AIR RESOURCES BOARD

Executive Order G-70-36-C

Relating to the Modification of the Certification of the
OPW Balance Phase II Vapor Recovery System
for Service Stations

EXHIBIT 4

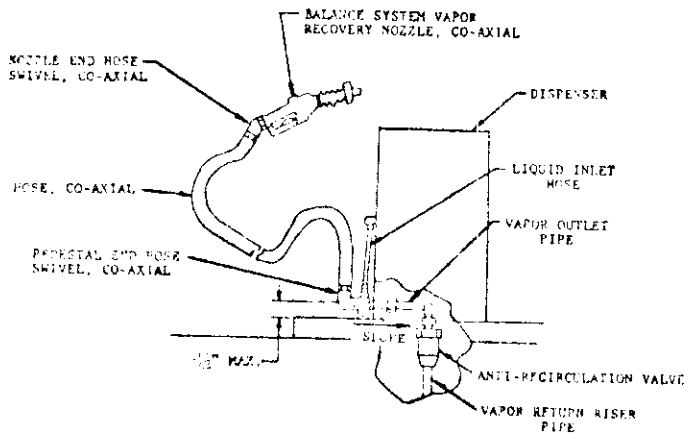
1. Include the B.F. Goodrich co-axial hose assembly, described in Exhibits 4 and 5, as an alternate hose configuration, and
